19 January 2021

Our ref: 202007\_003

**RE: SSD-10371 Trinity Grammar School redevelopment – Response to Submissions II  
– Traffic items**

Figure 5 - Existing Jubilee car park layout

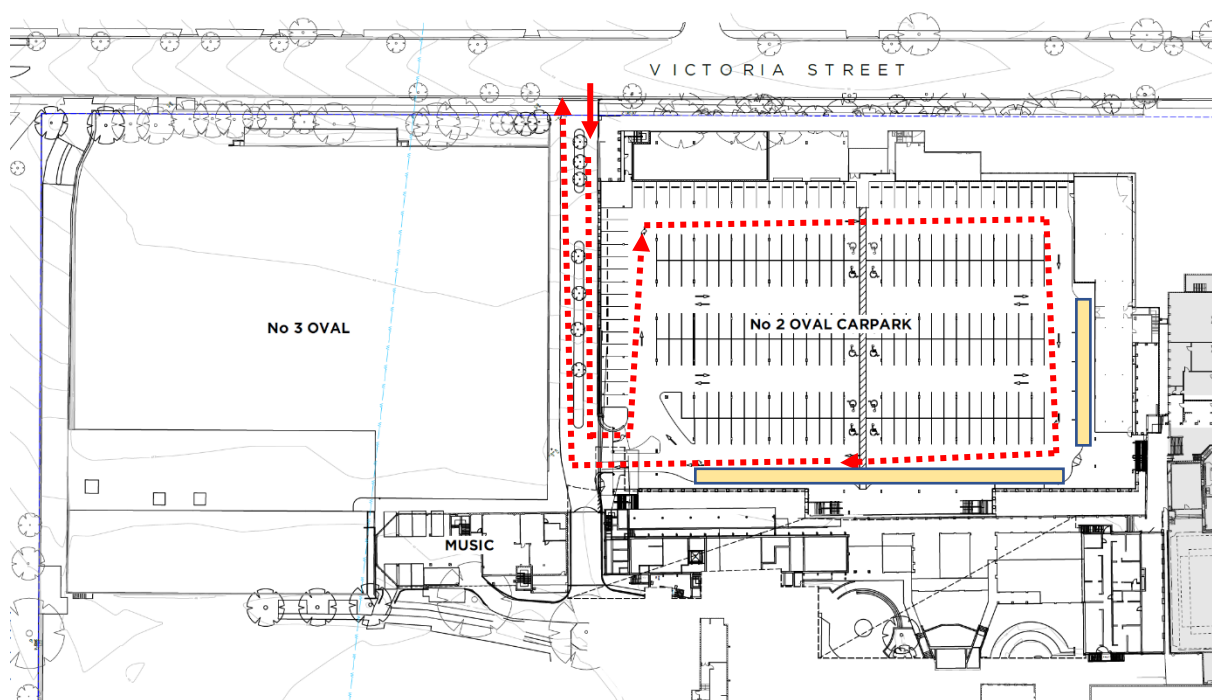
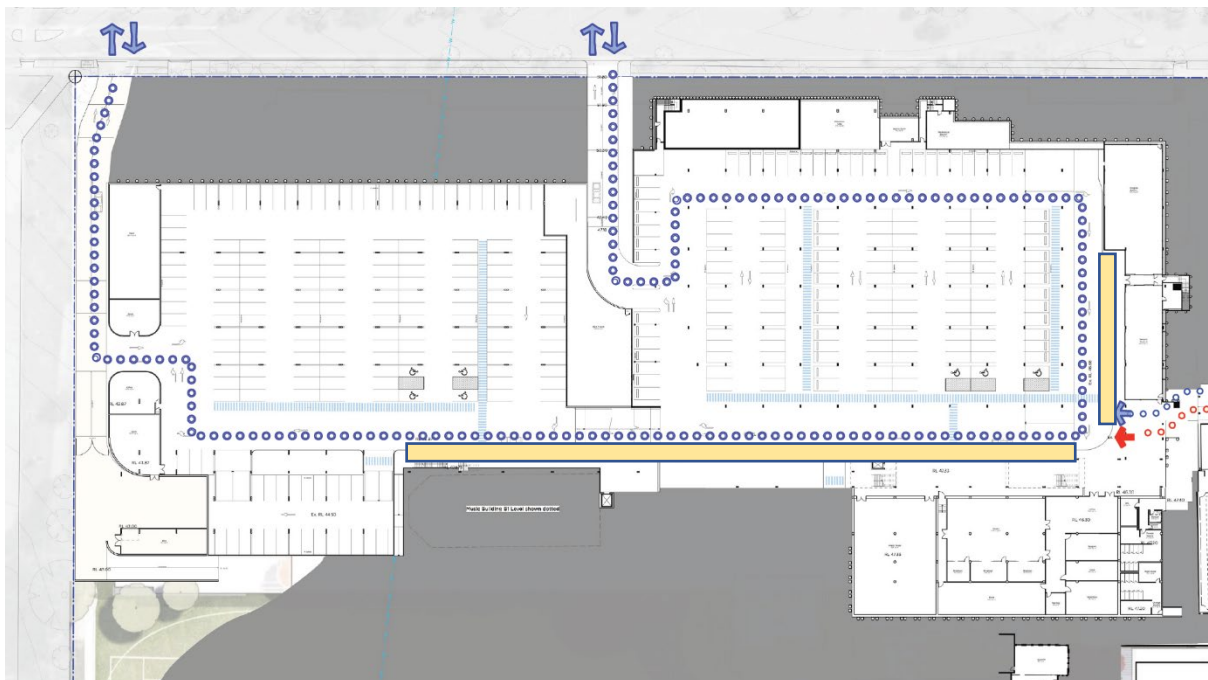
*The Department requests additional information be provided to understand the capacity and demand of the pick-up and drop off area. In this regard the Department notes that the analysis provided with the RtS indicates that under both the existing and the proposed arrangements the pickup/drop off would operate below capacity. However, the Department requires more information to substantiate the assessment as from the details provided in the public submissions and having regard to the previous findings of the NSW Land and Environment Court case (Council of Trinity Grammar School v Ashfield Council [2015] NSWLEC 1086), it appears likely that the current arrangements cannot accommodate the current demand, contrary to the information provided in the RtS. Therefore, the Department requires:*

- a) *detailed information based on surveys and data collection to demonstrate how the existing and proposed demand has been calculated. The Department notes the number of vehicle trips is very different from data provided in the original traffic assessment, and the increase in demand (82 AM trips and 45 PM trips) is inconsistent with the traffic assessment*

- b) *detailed information to demonstrate demand in the 20 minutes immediately before the AM bell and 20 minutes immediately after the PM bell, noting that peak demand is not spread over an hour but is usually concentrated over a very short timeframe. Where demand results in queuing on Victoria Street, an analysis should be provided of any change in queue lengths and time frame for the on-street queue to clear as a result of the revised design and increased student numbers.*
- c) *consideration of impacts on queue lengths as a result of other vehicles accessing the site to park.*

As can be seen in the diagram of the existing car park above (Figure 5), there are many car parking spaces along the wall parallel with Victoria St, along the entry/exit driveway, and the car parking aisles have a north-south orientation. The red dashed line indicates the path of travel for vehicles to circulate through the car park. This path of travel is to access both the pick-up/drop-off area which is marked in yellow, and any other car parking. Vehicles enter and exit out of the one driveway at Victoria St.

With the rotation of the car parking spaces running north-south, the major delays are caused by vehicles parking their vehicles that then block the circulation pathway. As delays

generally occur in the first half of the car park as vehicles first enter, this leaves less room inside the car park for other vehicles attempting to enter which reduces the internal queuing space and results in queues on-street. The fact that queues dissipate within 10-15 seconds on-street confirms that the internal delays are very brief in nature, allowing the on-street queue to clear quickly.

With a desire to remove this impact, the school has taken the approach to design out the cause of the problem by extending and redesigning the car park to lengthen the internal circulation/queue area and to reorient car parking aisles to an east-west orientation. See below for the new layout (Figure 6). This design essentially separates the two functions of *parking* and *pick-up/drop-off* to significantly reduce potential for delays to occur.

- Creates additional pick-up and drop-off spaces (marked in yellow);
- Significantly lengthens the internal circulation space;
- Increases the internal space which increases the on-site queuing capacity;
- Reorients the car park aisles to run east-west to remove opportunities for vehicles to park while circulating (and delay others in the process);
- Removes the majority of car parking spaces next to the circulation pathway (see blue dotted path) to reduce parking delays;
- Expands the footprint of the existing staff car park and connects it to the Jubilee car park;
- Redistributes parking spaces that were taken from the circulation pathway in Jubilee to the expanded staff car park; and
- Creates a separate entry and exit point during peak times to better manage demand.

This design is intended to resolve the existing on-street queuing issues by significantly reducing opportunities to park while circulating and increases the internal space by 40%. Our earlier RTS (dated 6 November 2020) included the table below that shows the differences between the existing car park and the future car park.

Figure 7 – Intersections reviewed

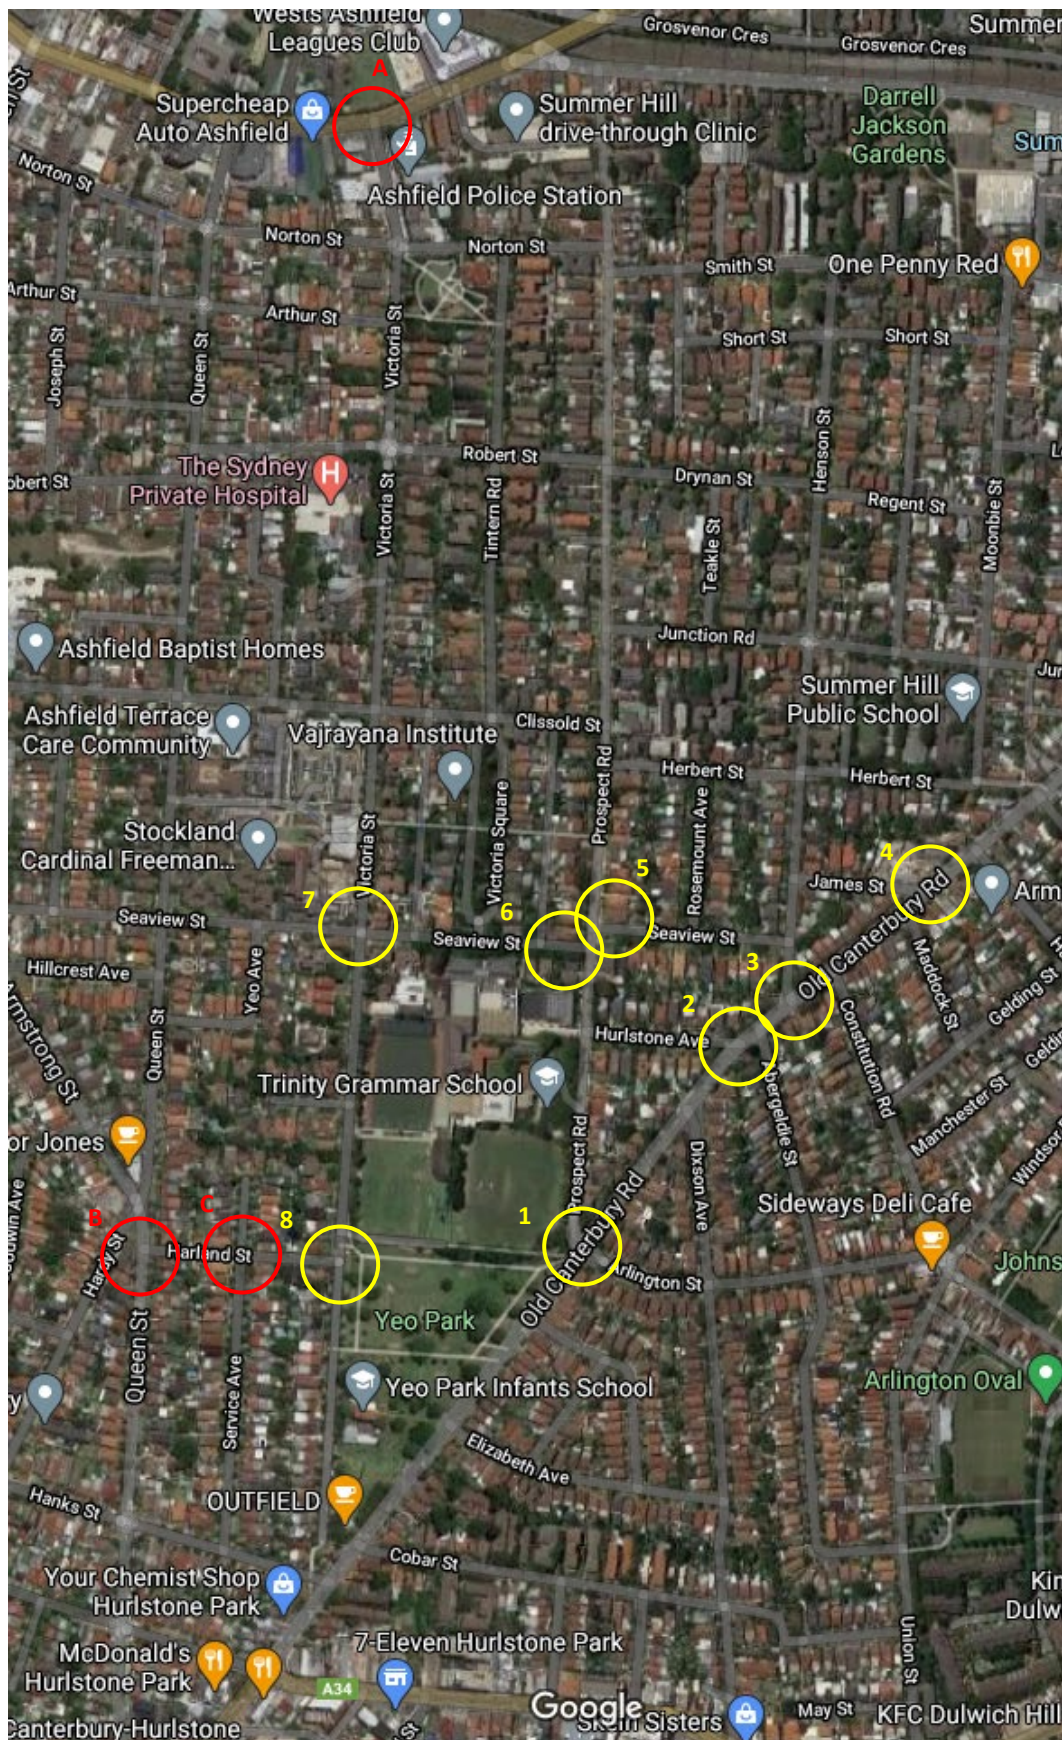
*The traffic assessment indicates that the majority of vehicle trips associated with the school use would travel either via Queen Street / Harland Street or Victoria Street / Liverpool Road, however no assessment has been provided of the impacts of the proposal on these intersections. Therefore, the Department requests that:*

- a) further traffic assessment of the impacts to the operation of these intersections be provided,*
- b) further assessment of the impacts to the operation of the intersection of Harland Street / Service Avenue.*

*Additionally, the analysis should compare the situation between a current lawful operation of the school (1500 students) vs the proposal for 2100 students. Where appropriate, consideration should be given to any mitigation measures to offset the traffic impacts of the proposal.*

The intersections that have been modelled (including those required in the SEARs) are intersections that any traffic to and from the school must travel through. Outside of these intersections, there are many paths of travel that vehicles may take to reach their destination and the proportion of traffic from the school dilutes.

- A - Victoria Street/Liverpool Road (Hume Highway);
- B - Queen Street/Harland Street; and
- C - Harland Street/Service Avenue.

These intersections are marked in red on Figure 7.

As part of the traffic assessment, the intersection with Harland St and Victoria St was modelled and found to operate at a Level of Service A in both peaks across existing and future scenarios. Given this is the intersection that all traffic from or between Service Avenue or Queen Street will pass through and is closest to the school, it will bear the greatest impact. If Victoria St/Harland St were operating at a poor level of service, then there would have been a need to model nearby intersections to understand the broader impact of the traffic distribution. As the level of service is good, it was determined that additional assessment or modelling was not required.

It should also be noted that Harland Street is less than 200 metres in length between Victoria Street and Queen Street so there is limited capacity for additional vehicles to queue, and if there was significant congestion at either the Queen Street intersection or Service Avenue,

this would impact the Harland Street/Victoria Street performance (which it does not). The excellent level of service implies there are no negative impacts borne at Service Avenue or Queen Street. As a preventative measure, there is an opportunity to remove car parking during school peaks on both sides of Harland St between Service Ave and Victoria St to maximise capacity.

As for the Victoria Street/ Liverpool Road intersection (a State road), this intersection is some 840 metres to the north of Seaview Street and requires vehicles to travel through another three intersections prior to reaching it. Our modelling of the intersection at Victoria Ave/Seaview St (which vehicles travelling to/from the school to Liverpool Road would pass through) shows that it operates at a Level of Service A in both the existing and future states. While 40% of the school's traffic is to or from the north, with the additional opportunities for traffic to disperse through other intersections, and the total additional vehicles per hour is less than 100, it is unlikely that the school traffic has any impact on the operation of this intersection.

Figure 8 - Trip distribution

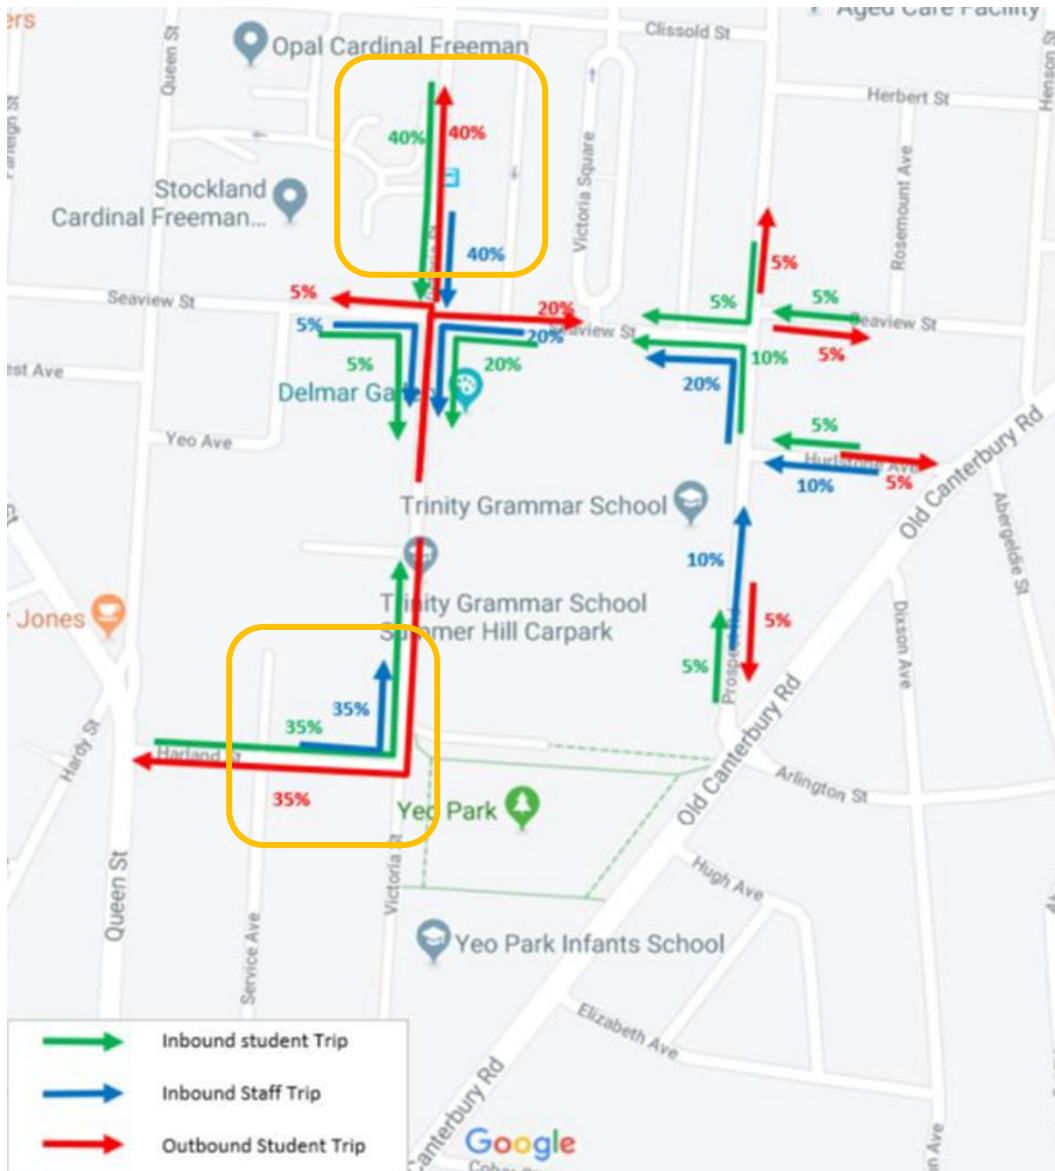
The Department states that “the traffic assessment indicates that the majority of vehicle trips associated with the school would use either Queen Street/ Harland Street or Victoria Street/ Liverpool Road” which is partly accurate.

The traffic assessment is based on the existing trip distribution captured in the data collected in October 2019. This distribution shows that 40% of the trips are to/from the north along Victoria Street, and 35% of the trips are to/from the west along Harland Street. The distribution is shown below, and the relevant locations shown in orange.

As can be seen in the Figure 7 and 8 above, two of the intersections queried by the Department intersect with Harland Street.
